Addendum Number 1

Campus Life Center Selective Building Envelope Repairs - Roof Replacement

Owner Project Number: H34-9542-JM-D

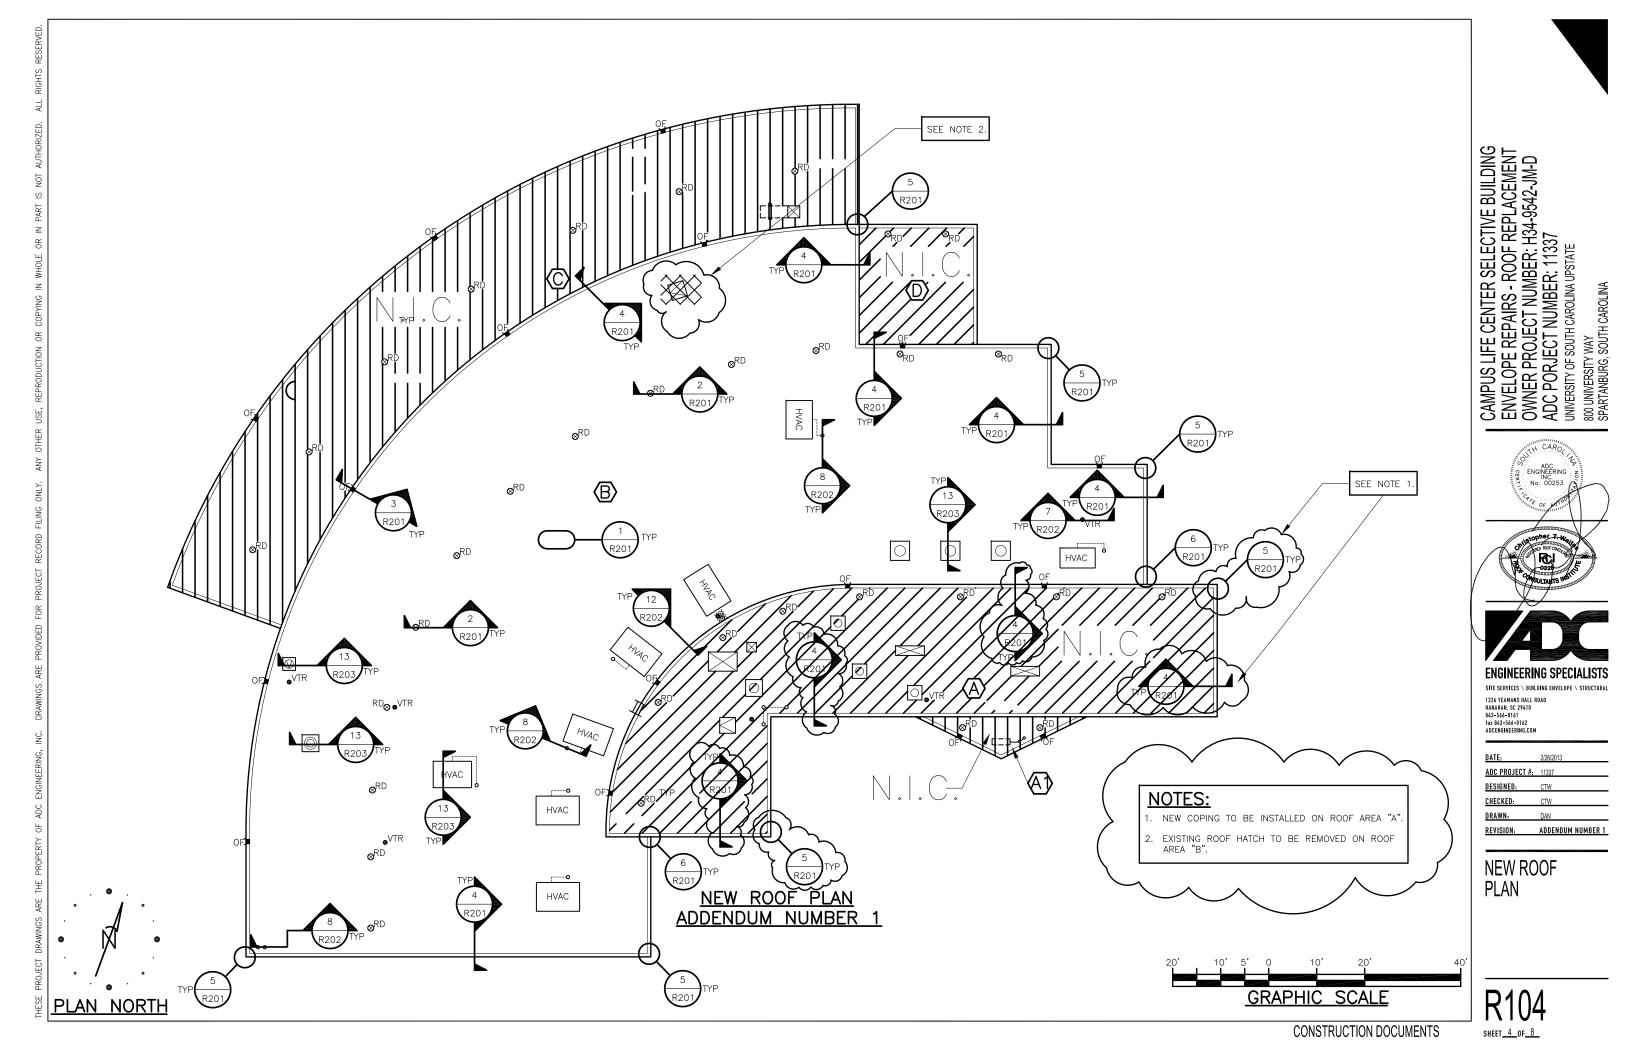
3. Is the roof hatch on area B functional?

a. No. Roof hatch is to be removed and deck repaired prior to new roof installation. See Addenda No. 1.

R	1	0	5
SHEET_	5	_0F	8

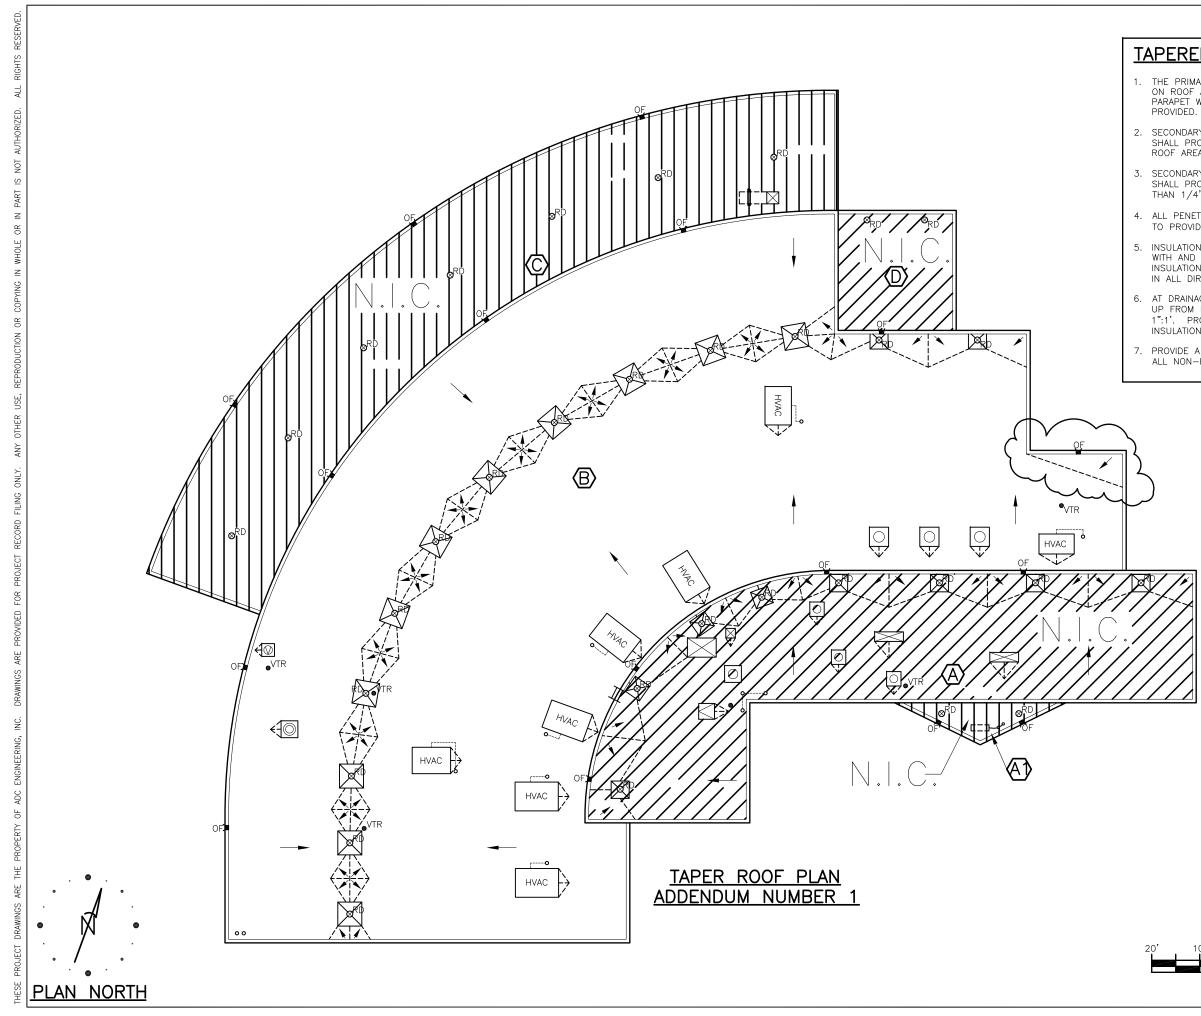
- 8. Delete Sheet R104 and replace with the attached Sheet R104.
- 9. Delete Sheet R105 and replace with the attached Sheet R105.
